MEMORANDUM

TO: Town of Kensington Mayor and Council

FROM: Marlene Michaelson, Senior Legislative Analyst

SUBJECT: Changes in Zoning for Kensington Sector Plan

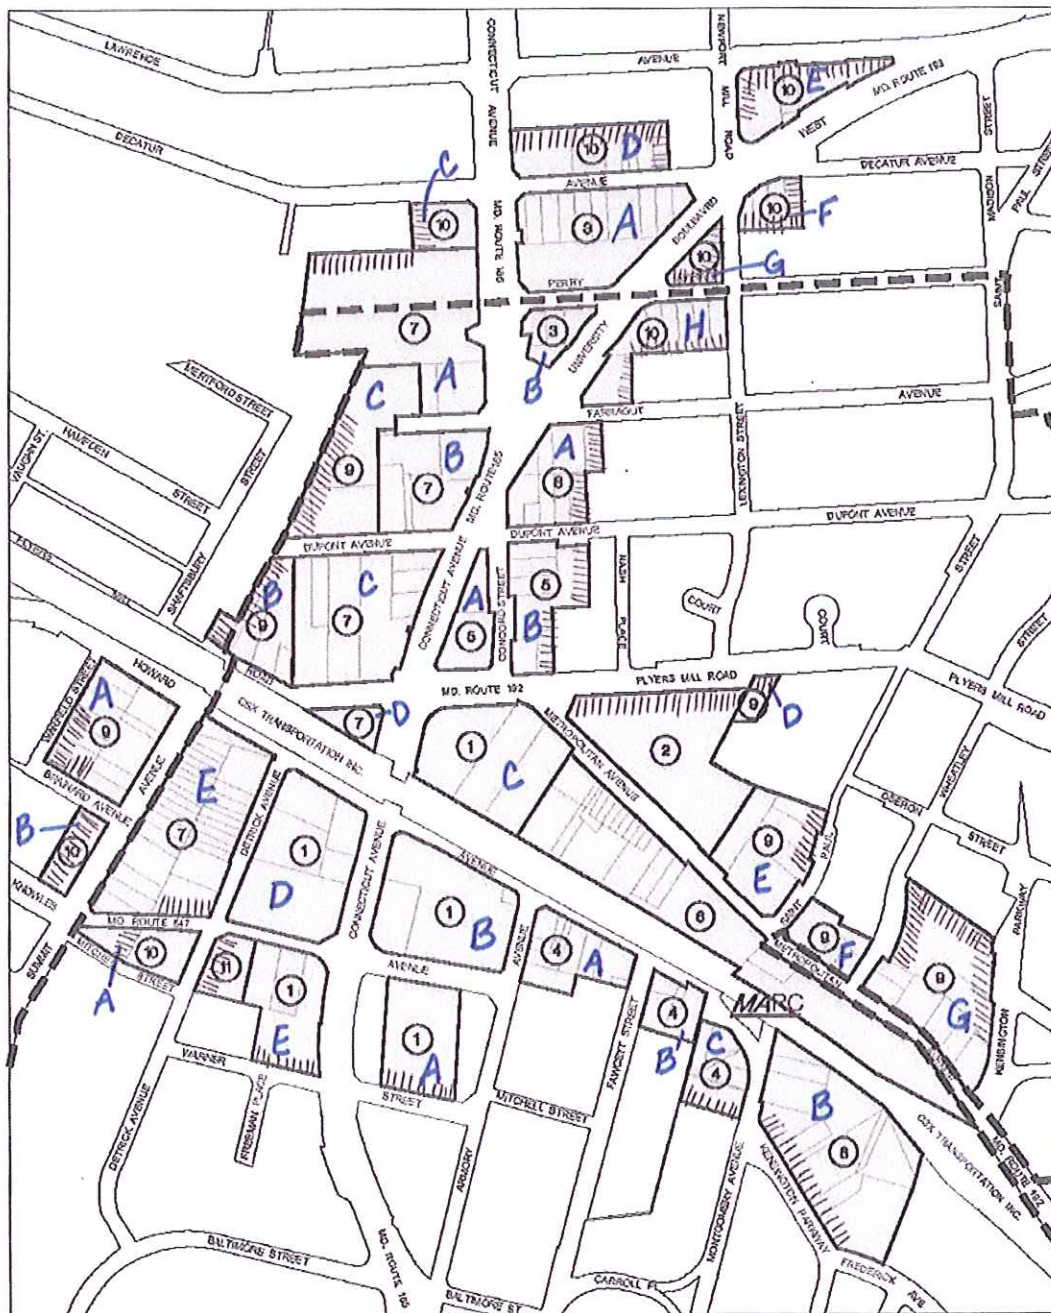
Area	Ref.	Exist- ing Zoning	Sector Plan Recommended Zoning	Testimony submitted by Town of Kensington	Staff Recommended zoning
1A	Baker's Union	C-0	CRT 2.5, C2.0, R2.0, H75	Limit on height on southern portion to 45' and keep open space.	Maintain open space and 45' height limit on southern portion. Emphasize importance of transition to the south.
1B	Safeway Block	C-2	CRT 2.5, C2.0, R2.0, H75		Add language for compatibility across Armory Ave
1C	Huggins	C-2	CRT 2.5, C2.0, R2.0, H75		
1D	Burka	C-2	CRT 2.5, C2.0, R2.0, H75		Add language about the possibility of putting green space west of Connecticut.
1E	10400 Conn. Ave.	C-O and O- M	CRT 2.5, C2.0, R2.0, H75	Limit height on 2 NW parcels to 45' and 50' and on southern portion to 45' but otherwise support 75'.	Add language to place tallest building at the corner of Connecticut and Knowles to retain the current bulk relationship. Step down building height to 60' on 3910 and 3906 Knowles Avenue lots and 45' on area 11 (3930 Knowles Avenues). Limit height along Warner Street to 45' with townhouse like scale and residential appearance; if redeveloped, no garage exposed along Warner.

2	3700 Plyers Mill Rd	C-2	CRT 2.0, C1.0, R1.5, H60		Specify 45' height limit along Plyers Mill Road and require residential appearance along Plyers Mill Road.
3A	Stubbs	O-M, C-1, and R- 60	CRT 2.0, C1.5, R1.5, H60		Support Sector Plan
3B		C-1	CRT 2.0, C1.5, R1.5, H60		Indicate that may not be possible to achieve full FAR
4A	Antique Row	O-M and C-2	CRT 2.0, C2.0, R0.5, H50		Add language re Village Center concept, importance of design, maintaining ground floor retail, and transitioning to adjoining residential properties.
4B	Antique Row	C-2	CRT 2.0, C2.0, R0.5, H50		See 4A

Area	Ref.	Exist- ing Zoning	Sector Plan Recommended Zoning	Testimony submitted by Town of Kensington	Staff Recommended zoning
4C	Antique Row	C-2 and C-T	CRT 2.0, C2.0, R0.5, H50		See 4A
5A		C-2	CRT 1.5, C1.5, R1.0, H60		Support Sector Plan
5B		C-T, C-O, & R-60	CRT 1.5, C1.5, R1.0, H60		Add language to keep current bulk relationship of 10605 with maximum height on Concord Street, require transition towards SF detached by requiring residential uses limited to 45 feet near the Nash Place residences.
6	Konterra	C-2 and R-60	CRT 1.5, C1.5, R1.5, H60		
7A	Kaiser	O-M, C-1, C-2	CRT 1.5, C1.0, R0.5, H60		Add requirement to lower height at back of site and where it is across from residential. Require that the rear of site be kept in open space. Stress compatibility and transition.
7B	Savannah Restrt.	C-2	CRT 1.5, C1.0, R0.5, H60		Support Sector Plan zoning and extend 7B to include all of the Calomiris property. (Change zoning on area being moved from 9C to 7B to CRT 1.5, C1.0, R0.5, H60 and indicate need for transitions).

7C		C-2 & R-60	CRT 1.5, C1.0, R0.5, H60		Support Sector Plan
7D		C-2	CRT 1.5, C1.0, R0.5, H60		Support Sector Plan
7E		C-2	CRT 1.5 C1.0, R0.5,H60		Support Sector Plan
8A		C-1, C-O, and R- 60	CRT 1.5, C1.0, R1.0, H60		Add compatibility and transition language to keep existing bulk relationship between Schlesinger property and the adjoining SF detached. (Highest densities along Connecticut Ave. and lower densities/height and residential appearance on eastern edge of property.)

Area	Ref.	Existing Zoning	Sector Plan Recommended Zoning	Testimony submitted by Town of Kensington	Staff Recommended zoning
8B	Johnson's	C-1, I-1, and C-2	CRT 1.5, C1.0, R1.0, H60		Add language re Village Center concept, civic green, and need to transition to existing single family homes across Kensington Pkwy. Keep at Plan recommended densities and encourage optional method to obtain amenities for Village Center.
9A		I-1, C-2, and C-T	CRN 1.5, C1.5, R1.5, H45	KC: C-T portion of block should be zoned CRN 1.0, H45	Add language re transitions to residential neighborhoods to the south and west, particularly at Southwest corner.
9B		C-2	CRN 1.5, C1.5, R1.5, H45		Reduce max. C and R densities consistent with properties to the east and new recommendation for properties to the north. Change zoning to CRN 1.5, C1.0, R0.5, H45
9C	Jiffy Lube	C-1, R-60, and C-2	CRN 1.5, C1.5, R1.5, H45		Move entire Calomiris property to 7B and change zoning to CRT 1.5, C1.0, R0.5, H60 and indicate need for transitions. Note this keeps the same total density for the entire Calomiris property but reduces the commercial and residential maximums on the portion that was in 9C consistent with the rest of 7B.) Change zoning on remaining portion of 9C to CRN 1.5, C1.0, R0.5, H45

9D		C-2	CRN 1.5, C1.5, R1.5, H45		Next to the park, not much redevelopment potential, change zoning to CRN 1.0, C1.0 R1.0 H45
9E	Crafts/ Services District	C-2	CRN 1.5, C1.5, R1.5, H45		Add language regarding transitions to single family homes across Saint Paul.
9F	Crafts/ Services District	C-2 and R-60	CRN 1.5, C1.5, R1.5, H45		Add language regarding transitions to single family homes.
9G	Crafts/ Services	C-2 and	CRN 1.5, C1.5, R1.5, H45		Change zoning to CRN 1, C.75, R1.0, H45 and add

Area	Ref.	Exist- ing Zoning	Sector Plan Recommended Zoning	Testimony submitted by Town of Kensington	Staff Recommended zoning
	District	C-T			language regarding transitions to surrounding R-60 development.
10A	Kaiser Family House	C-T and R-60	CRN 1.0, C1.0, R0.5, H45		Keep CRN recommendation for C-T property. Change zoning to keep Kaiser house as R-60 until M-NCPPC determines whether it is historic. (Plan should note that Kaiser house is appropriate for CRN zoning if M-NCPPC determines it is not historic; encourage them to make this determination before the SMA).
10B		C-T	CRN 1.0, C1.0, R0.5, H45		Support Sector Plan
10C		C-T	CRN 1.0, C1.0, R0.5, H45		Add language for compatibility and transition to adjoining and confronting residential across Decatur
10D	Decatur and Conn.	C-T and R-60	CRN 1.0, C1.0, R0.5, H45		Change zoning to CRN 1.0, C 0.75, R1.0, H45. Reduce C and increase R to allow the possibility of townhouses since surrounded on 3 sides by R-60. Add language re compatibility to existing residential to the north.

10E	Credit Union/ 7-Eleven	C-1 and R-60	CRN 1.0, C1.0, R0.5, H45		Change zoning to CRN 1.0, C1.0, R1.0 H45. Increase R to allow the possibility of townhouses. Keep east end in green space.
10F		C-1 and C-T	CRN 1.0, C1.0, R0.5, H45		Change zoning to CRN 1.0, C0.75, R1.0. Reduce C and increase R to allow the possibility of townhouses.
10G	Univ./ Lexington/ Perry	C-1	CRN 1.0, C1.0, R0.5, H45		Address compatibility with residential neighborhood to the east.
10H	Lexington/ Perry	C-1, C-T, and R-60	CRN 1.0, C1.0, R0.5, H45		Change zoning to CRN 1.0, C1.0, R1.0, H45. Increase R to allow the possibility of townhouses. Add language requiring residential

Area	Ref.	Exist- ing Zoning	Sector Plan Recommended Zoning	Testimony submitted by Town of Kensington	Staff Recommended zoning
					appearance for lots that are closest to residential development to the east and south.
11	Detrick/ Knowles	CT	CRT 2.5, C2.0, R2.0, H60		Change zoning to CRT 1.5, C1.5, R1.5, 45 to provide transition to Kaiser house to west. Add language about importance of transition to nearby residential properties.
